Sundry Print Report

Well Name: CHACON JICARILLA

Type of Action: Plug and Abandonment

CONDITIONS OF APPROVAL

P&A WBD Proposed

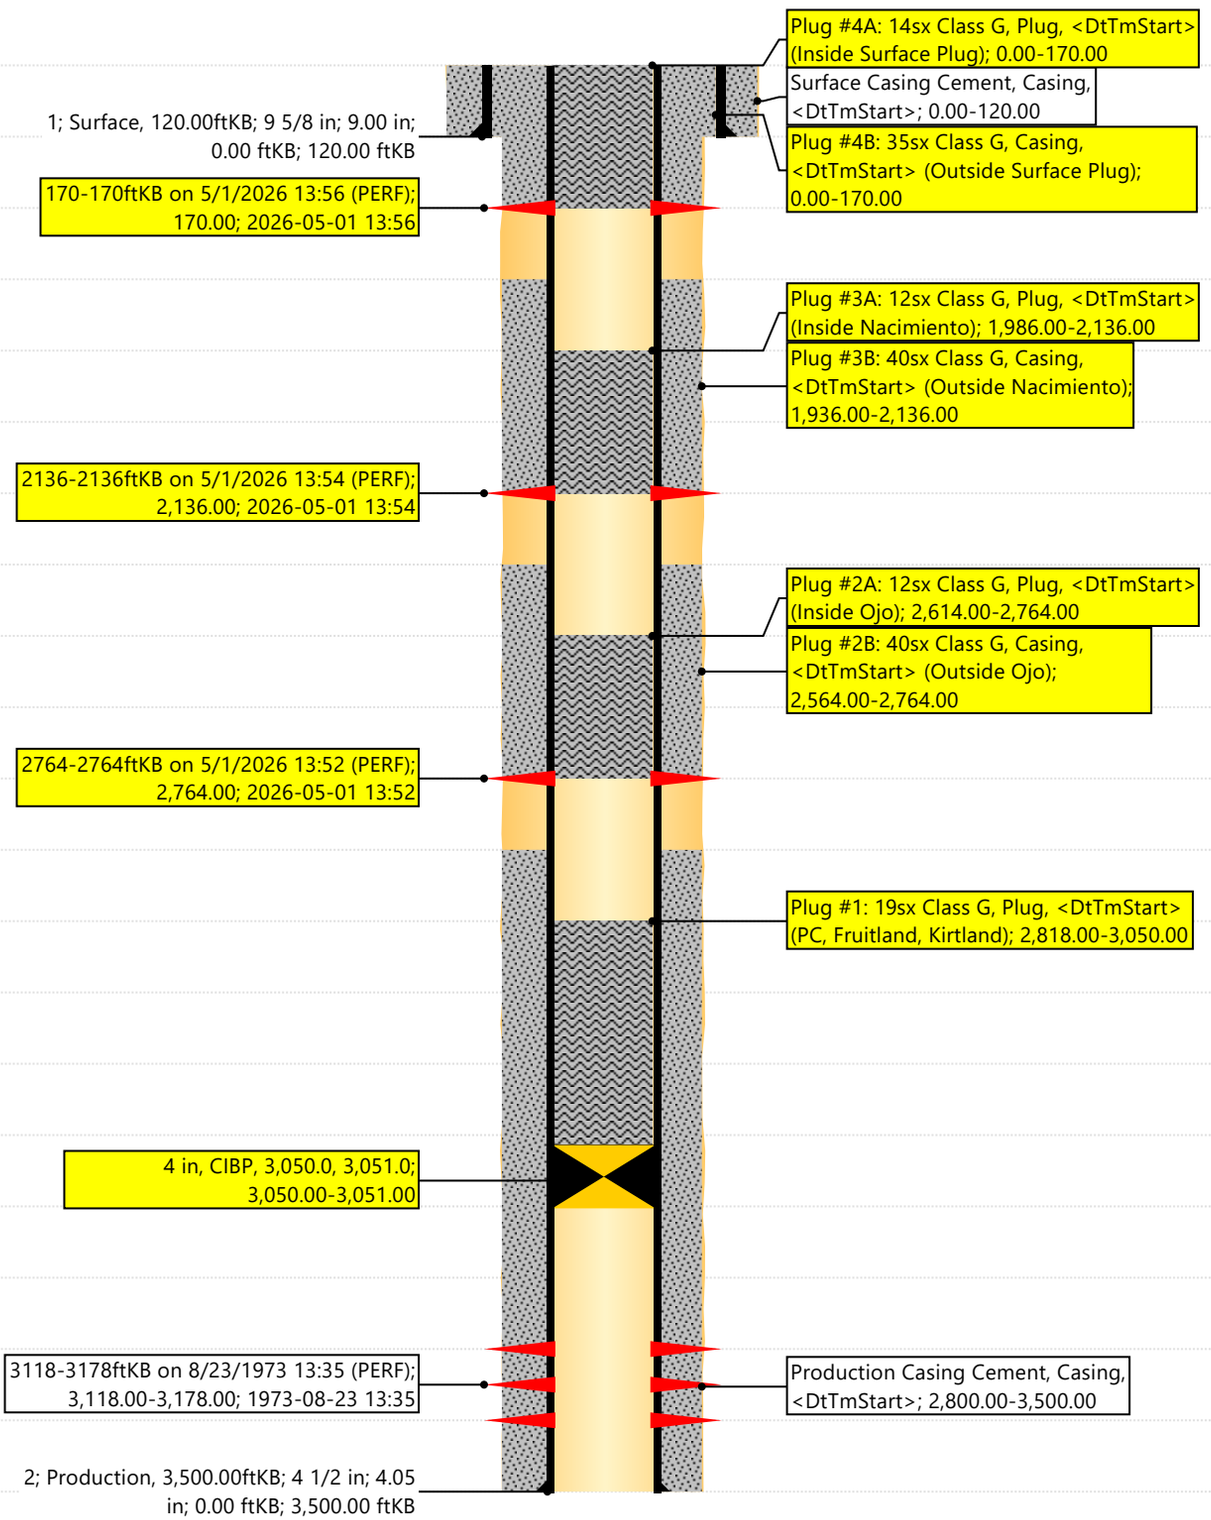
a. Modify Plug 1. The CIBP/CICR should be set at ± 3068' and the TOC at 2768' to account for BLM regulations.
   a. Confirm surface casing setting depth. The available completion reports have 138', the procedure has 120'. If 138', modify plug 4 to cover 50' below surface casing shoe.

- Modify Plug 1. The CIBP/CICR should be set at ± 3068' and the TOC at 2768' to account for BLM regulations.
